# **A G E N D A**

## **Architectural Review Board**

**November 28, 2017**

9 K

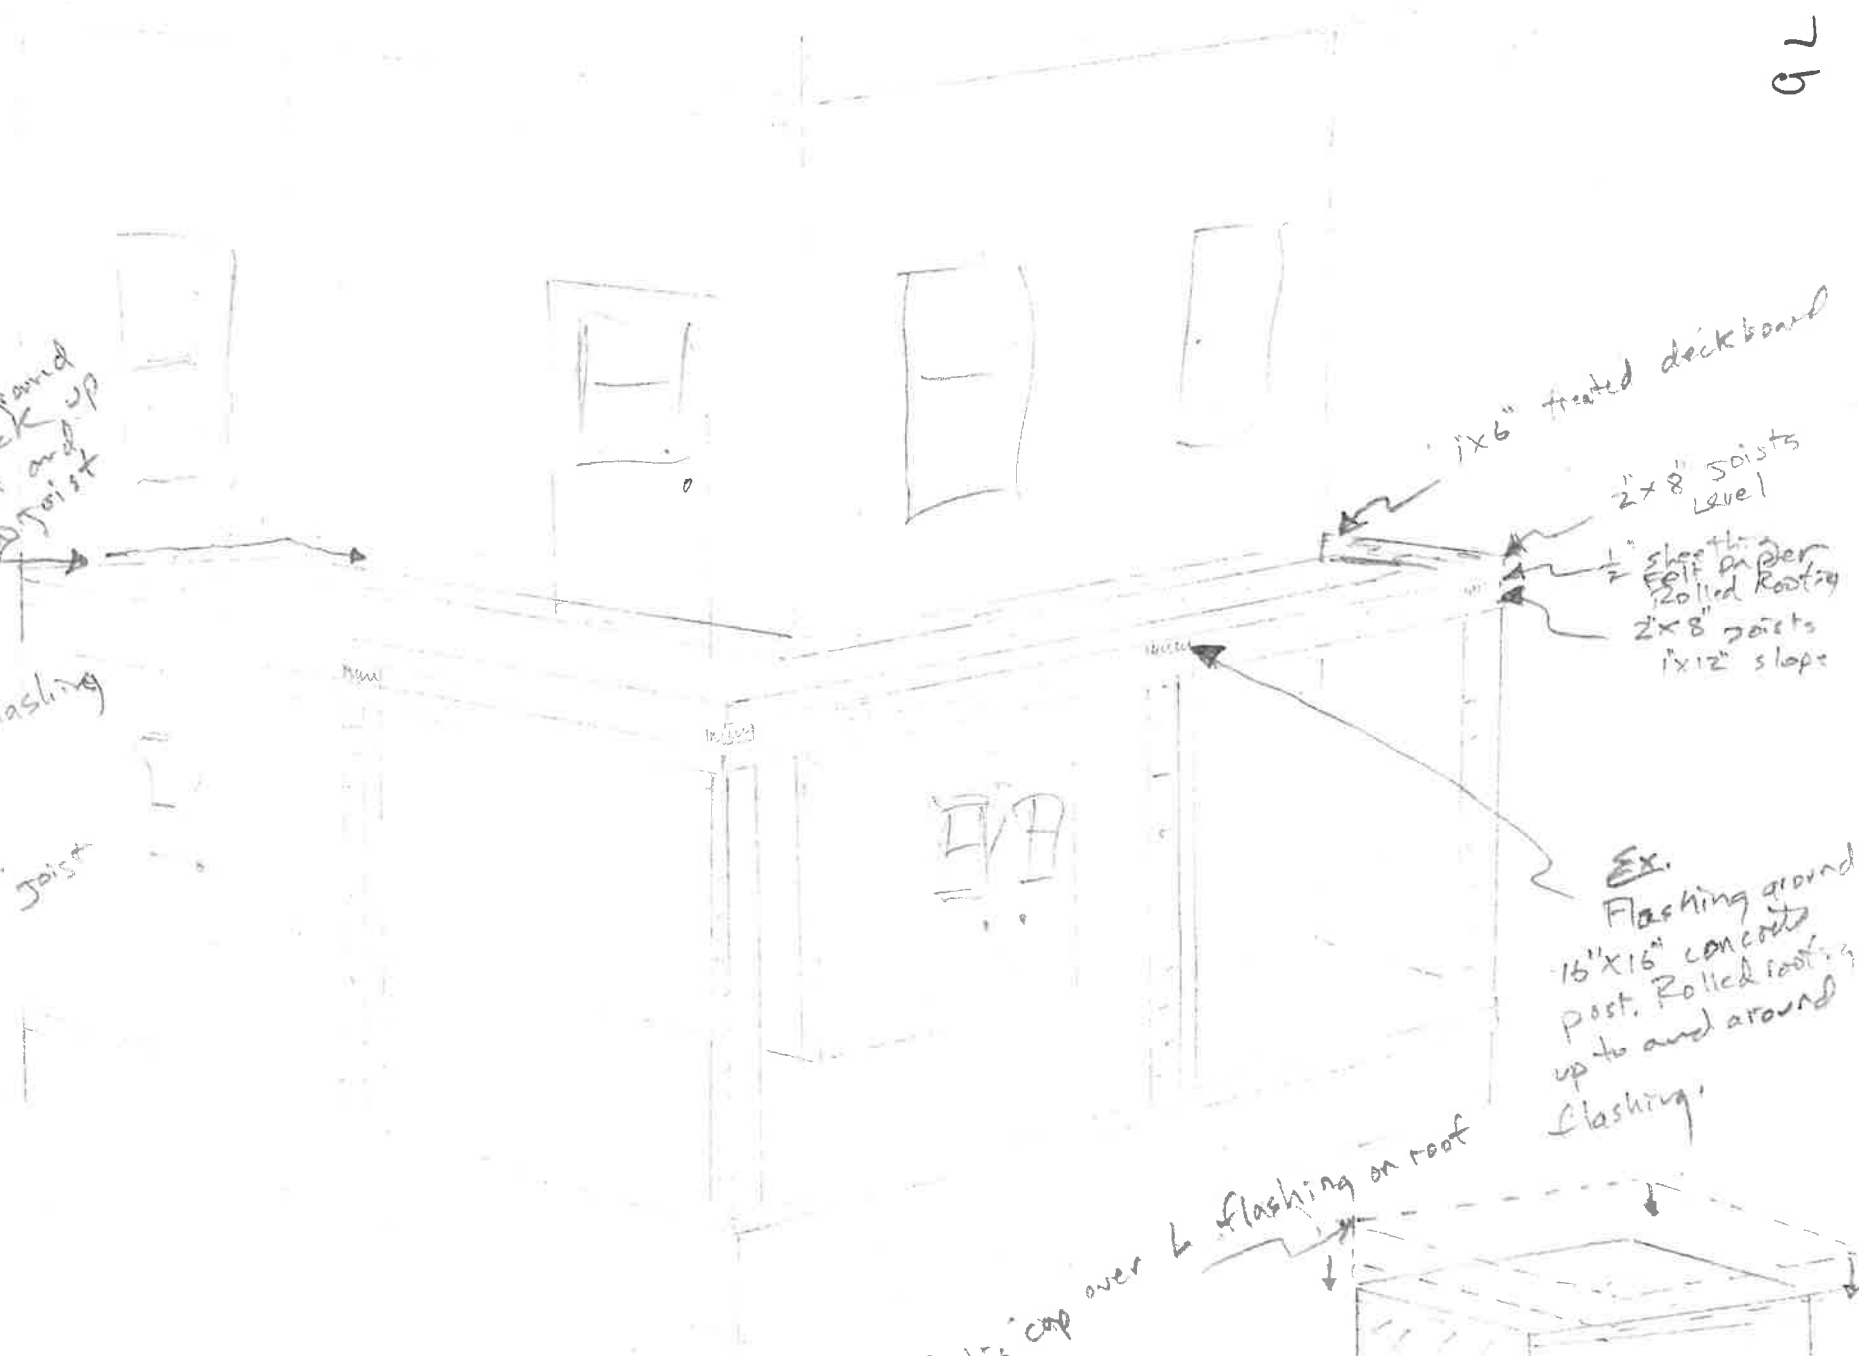
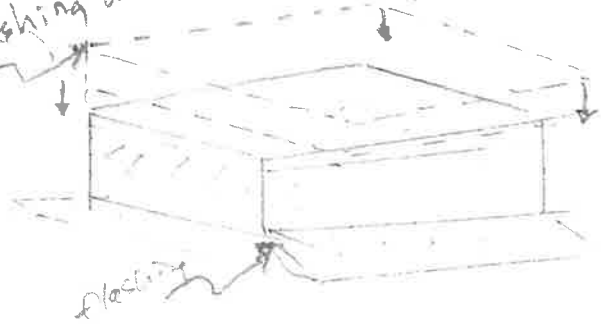
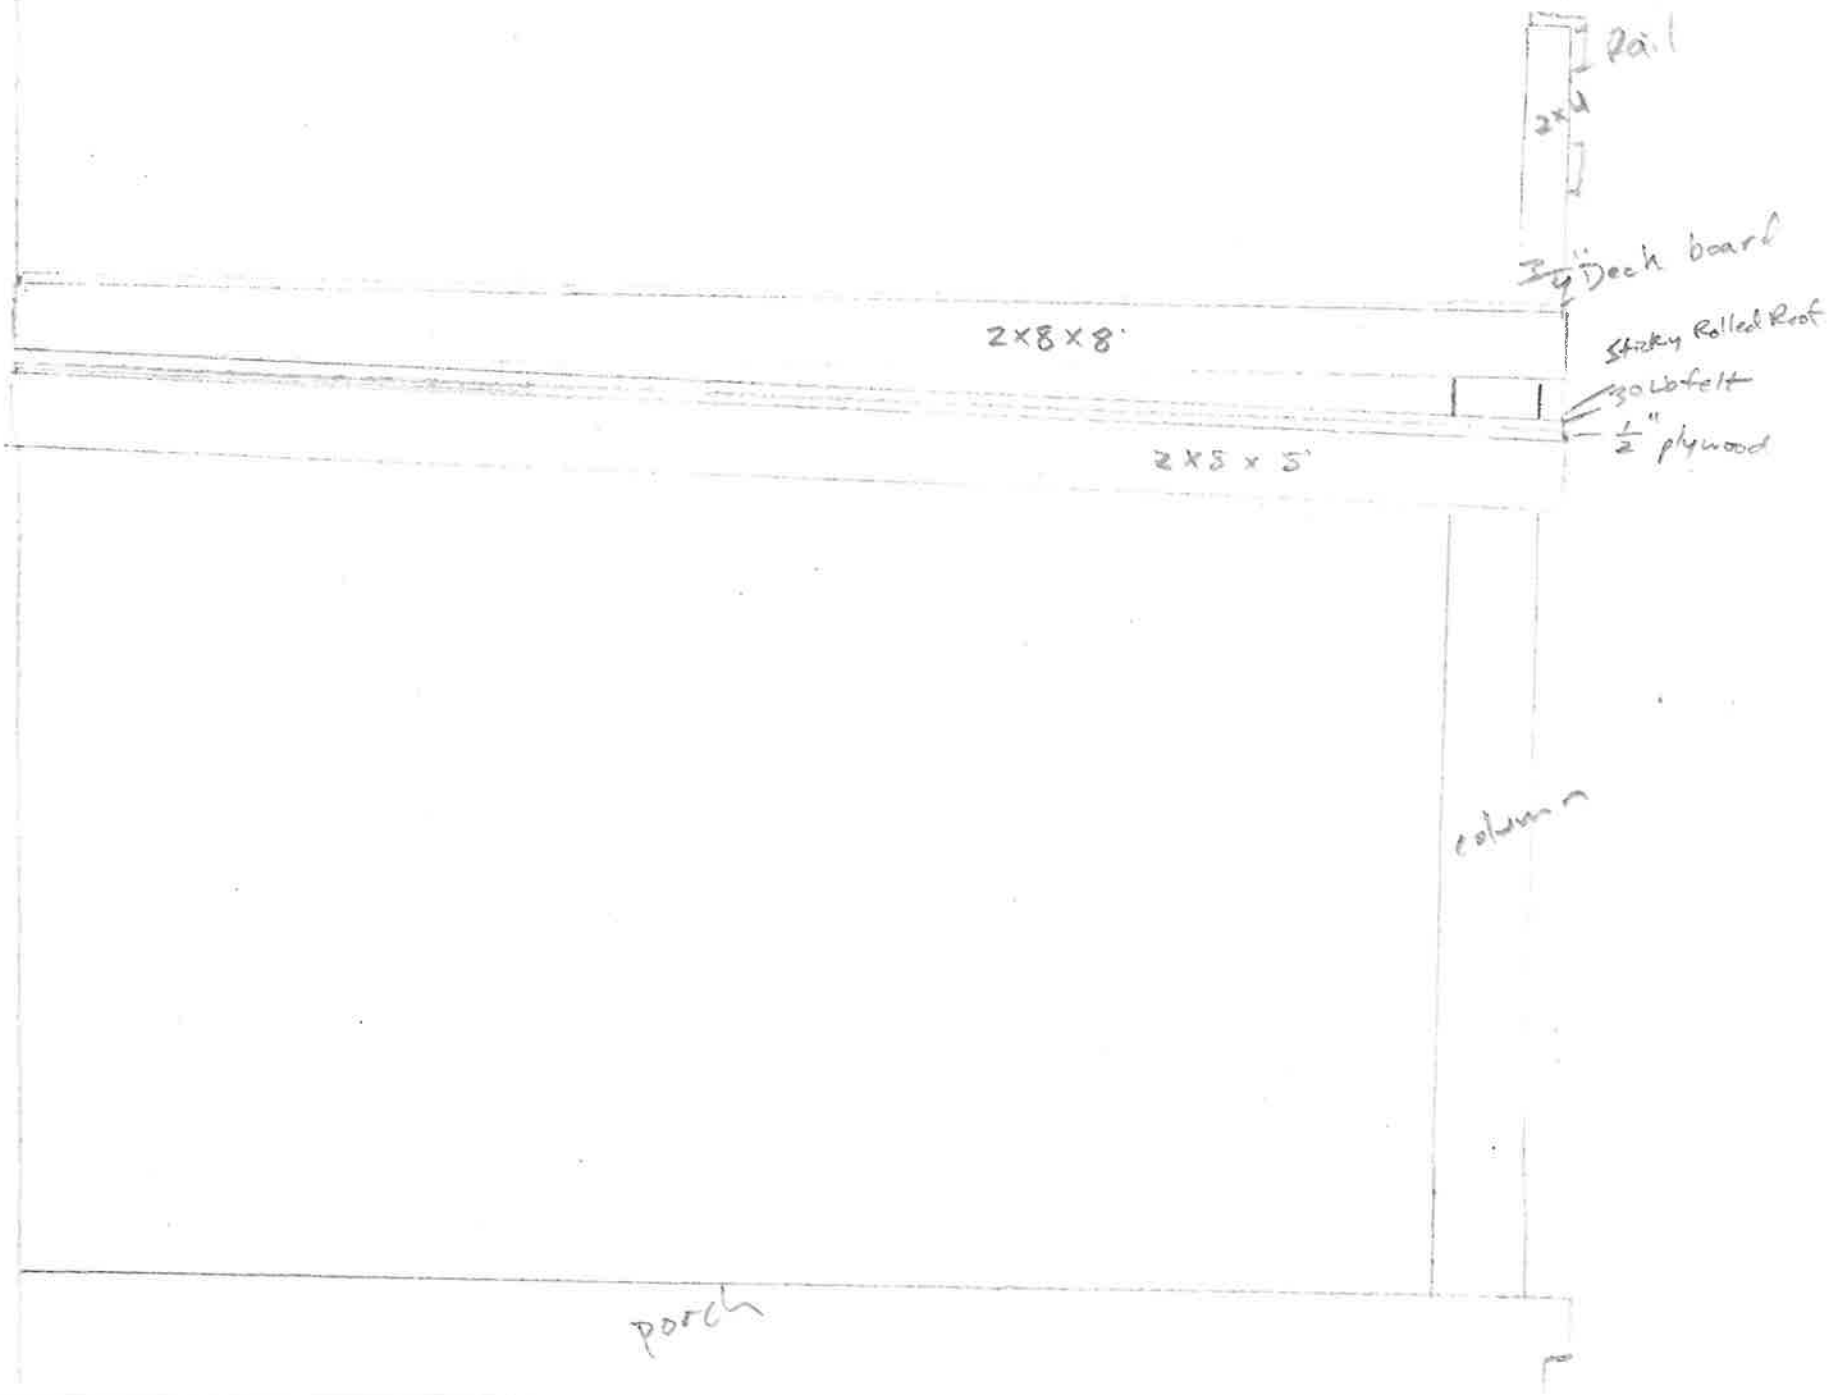
- Add a porch roof and balcony on the existing split face block columns on the front (Goldthwaite) and side (Warren Court) of the porch with a baluster utilizing elements found from what is believed to be the original baluster in the house. The top and bottom rail will be built up evenly to reach the required 36" rail height. No roof is proposed over the 2<sup>nd</sup> floor gallery;

- Add a matching porch/balcony over the existing door to the rear of the Warren Court side of the house as illustrated;
- Convert two windows to doors (steel door proposed) that will have a custom muntin made to match the windows;

- Within the historic district (with the exception of some Colonial Revival style houses, which this is not), extant second story porches are generally under cover of a roof and not open galleries. One of the 4 Sisters Houses on Perry Street used to have an open, upper gallery, but the owner petitioned to put "the same" porch roof on as the other houses in 2002. A photo of that porch is also attached.

New 4' wall

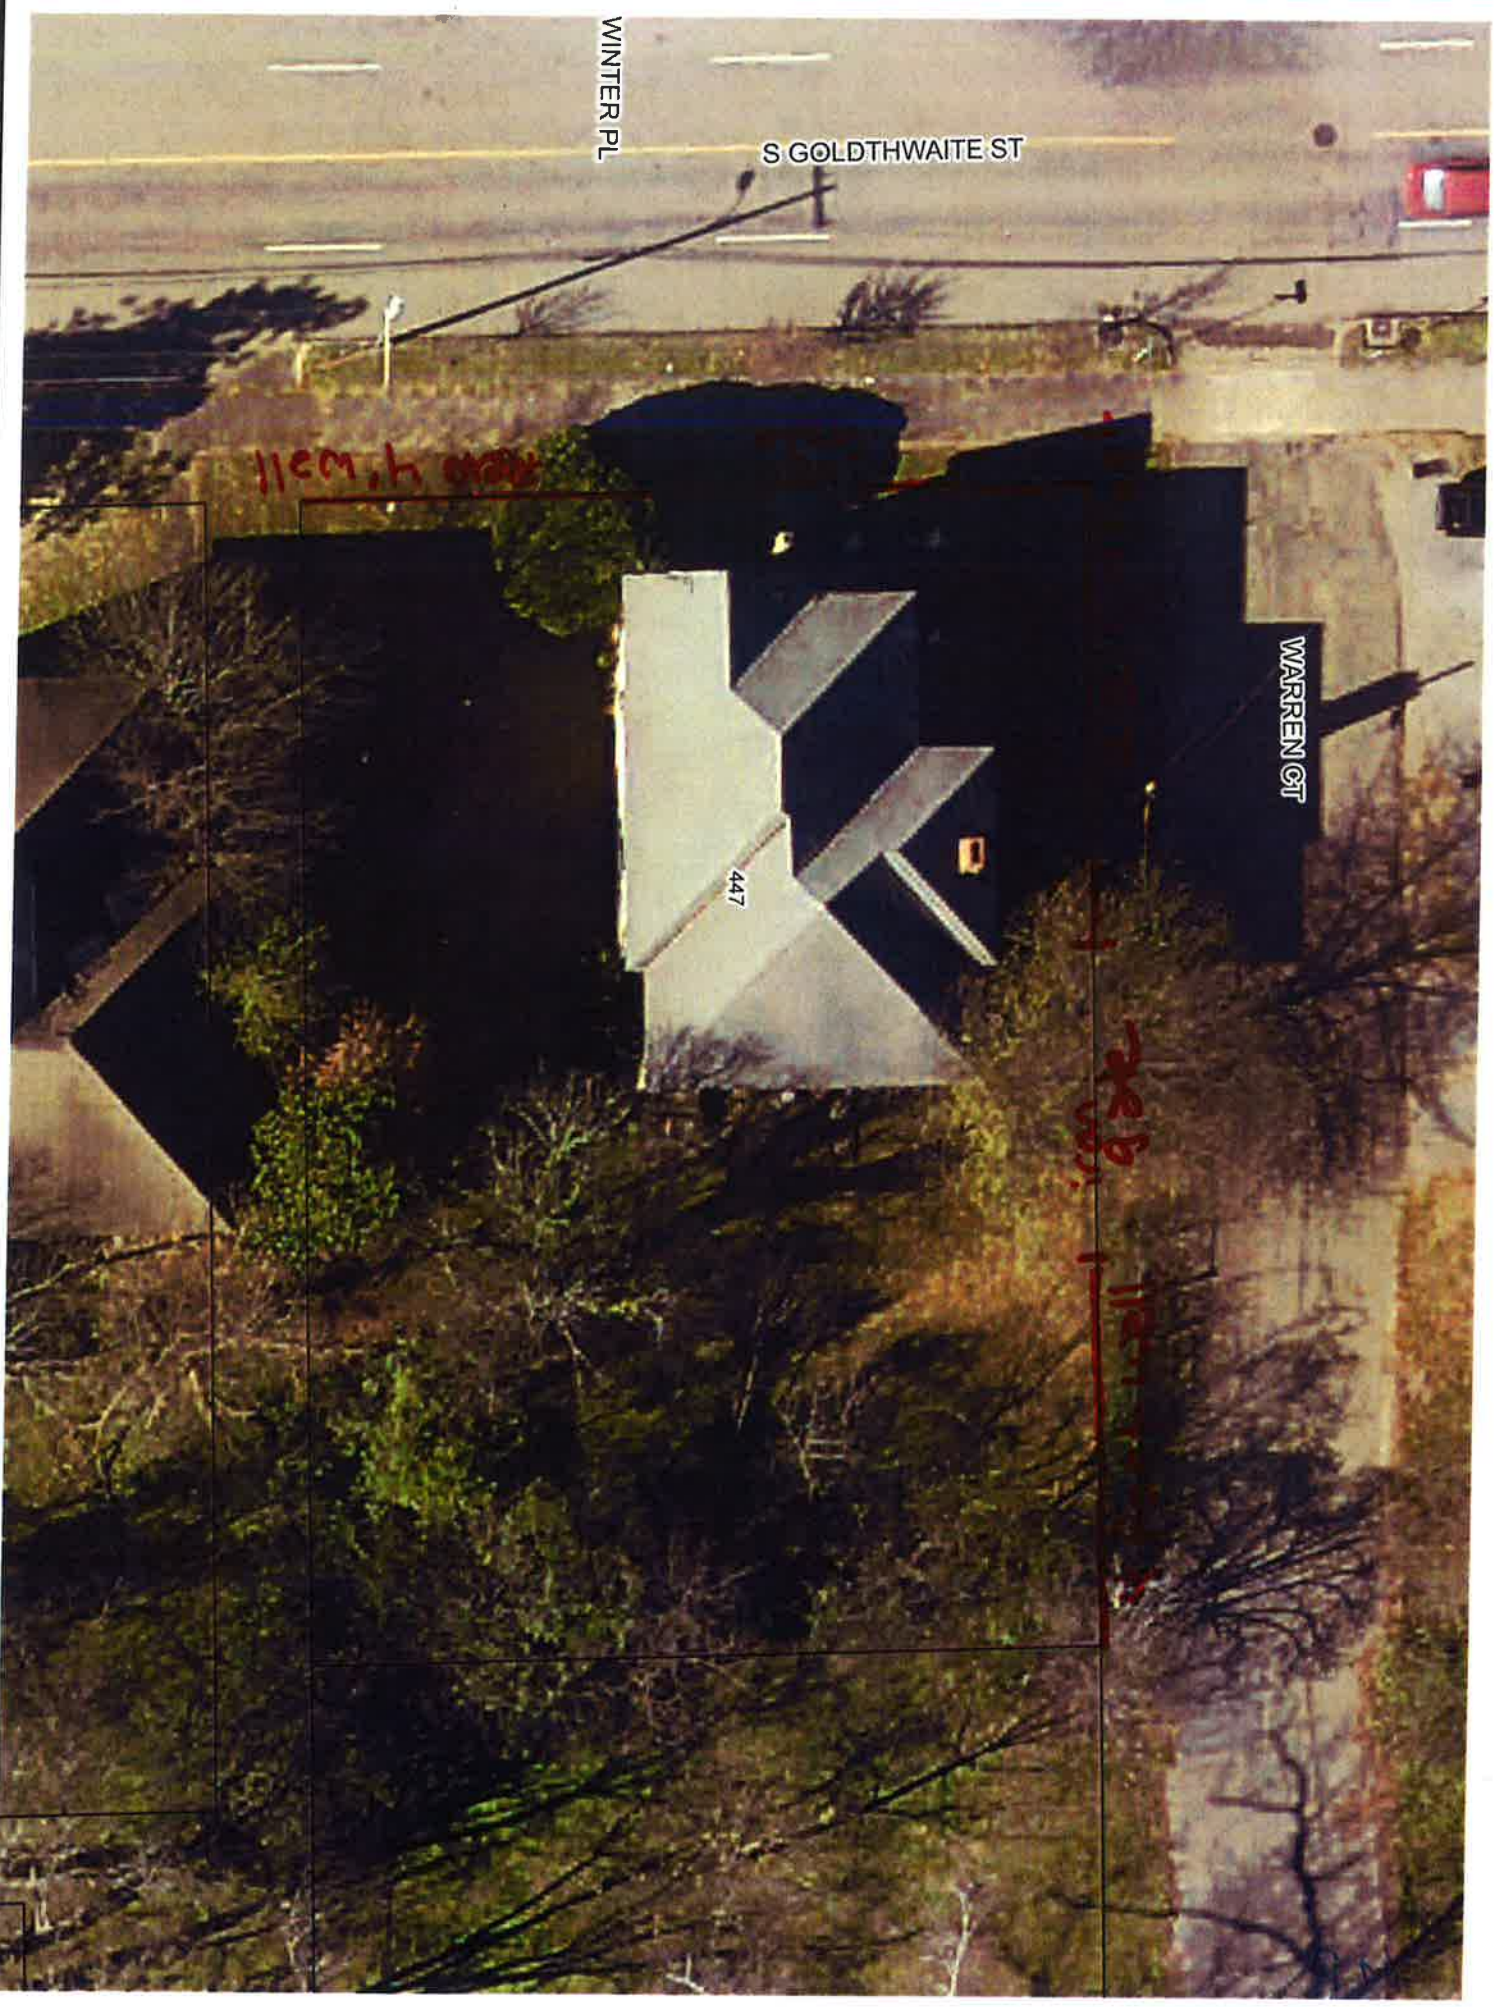
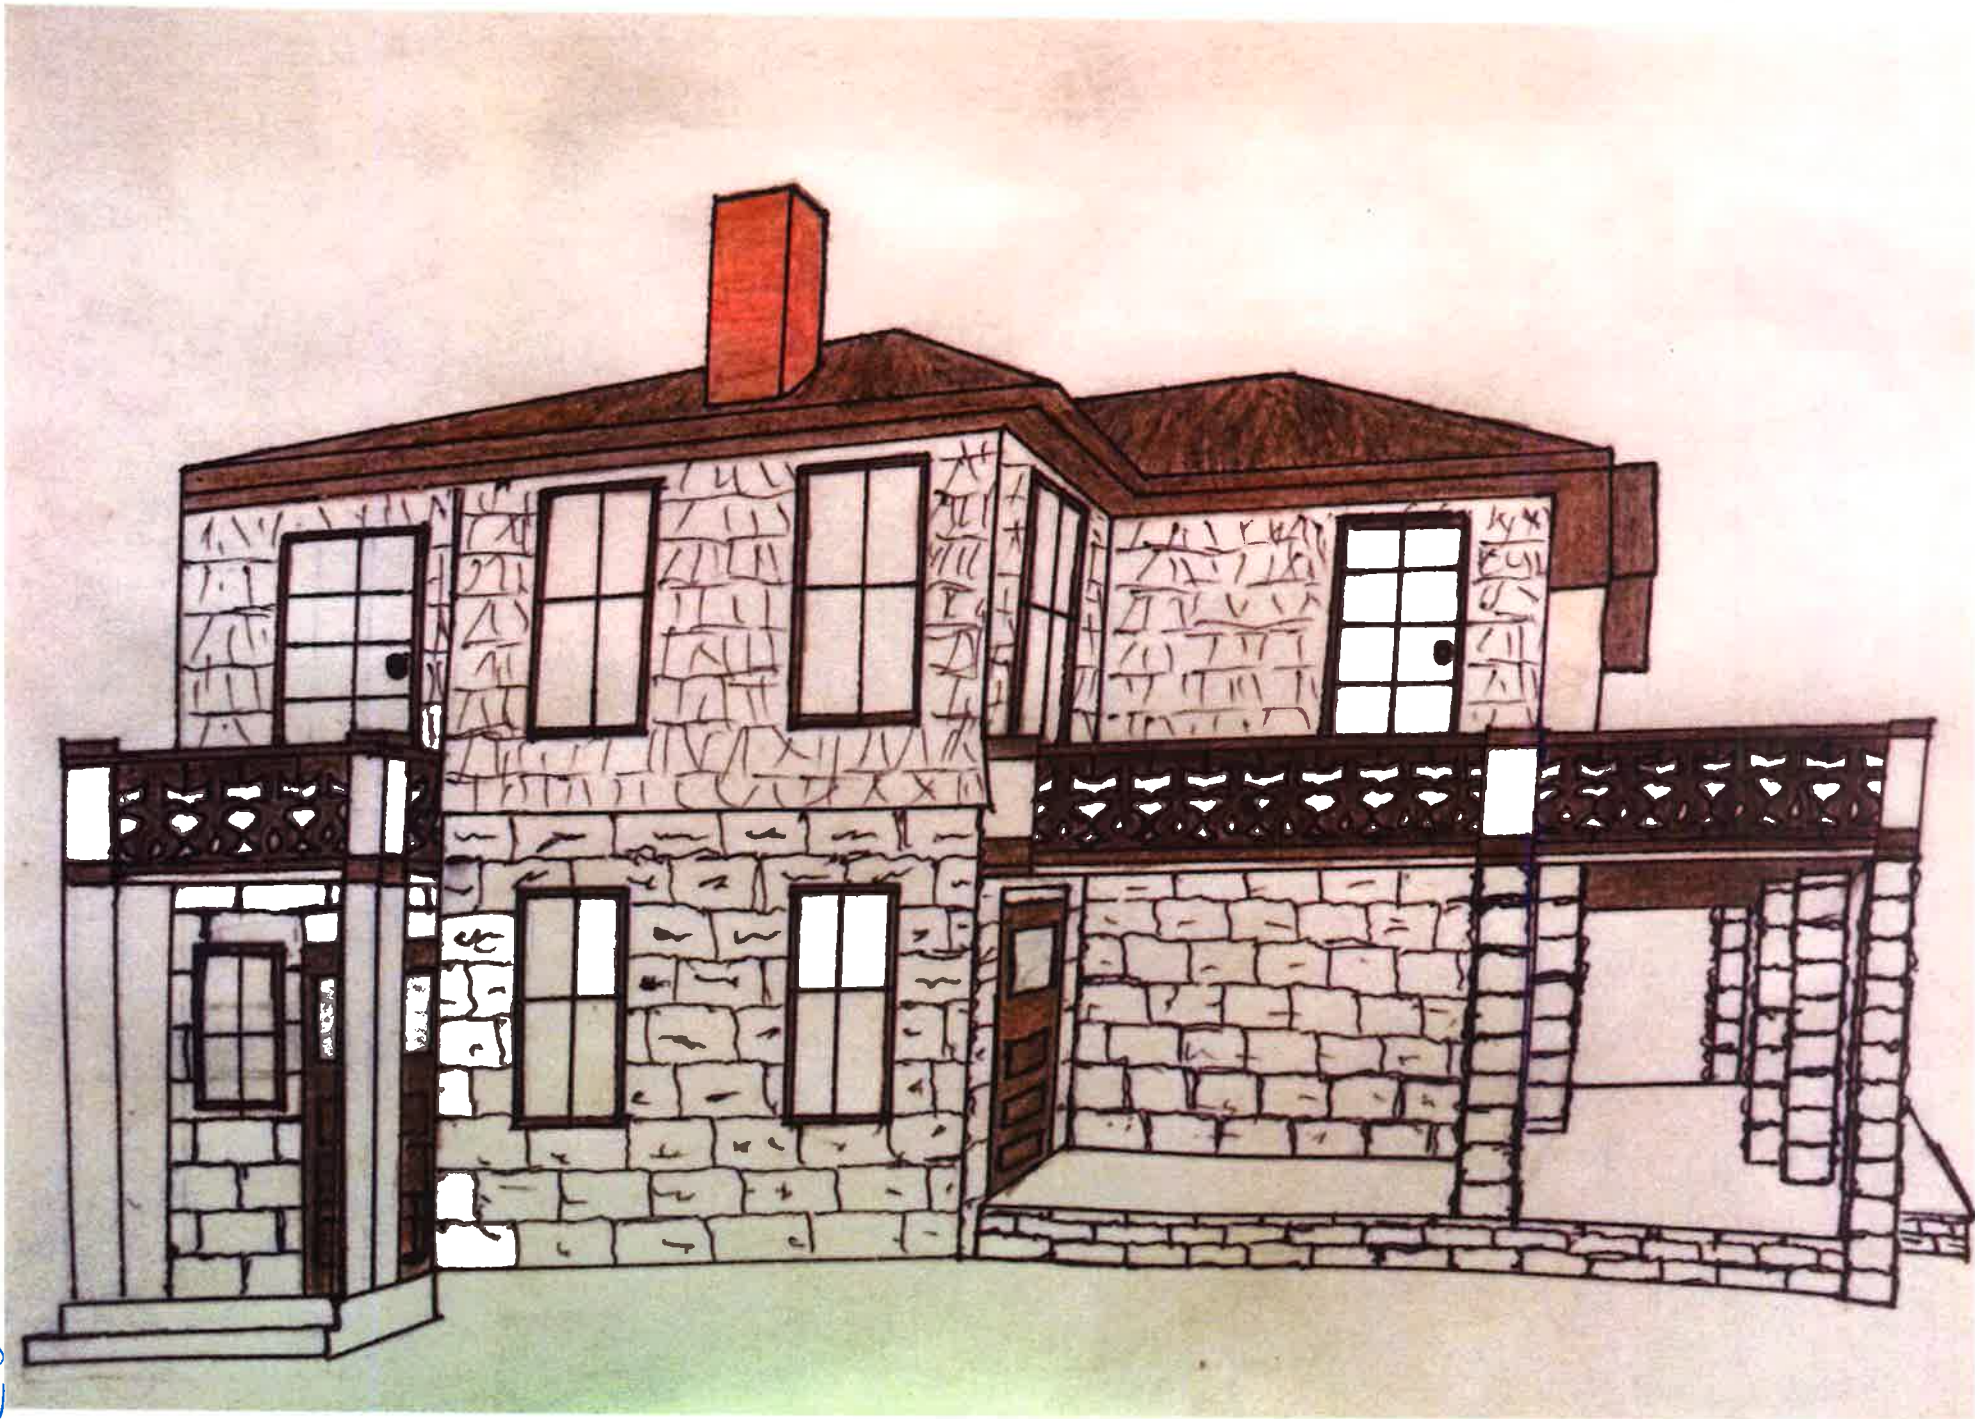
- 20x20 (2 space) parking pad on the Warren Court side of the property;
- A 4'high front and side yard enclosure with metal gates (front entry and driveway gates) along the Goldthwaite and Warren Court property lines. Chain link fence along Warren Court would be removed. Fence/wall material proposed is treated wood, precast concrete, and a vinyl simulated stone panel.

- Vinyl has not been approved as a front yard fence, and was approved in one instance where someone installed it in a rear yard (corner lot) without permission and was allowed to retain it subject to a vegetative screen being planted. The precast concrete sort of simulates the split face block, the vinyl stone panel does not resemble any conventional construction detail in any of our historic districts.

- Parking pad material should be specified
- Windows should be approved as simulated divided lite, as the 2500 series has a grill between the glass option
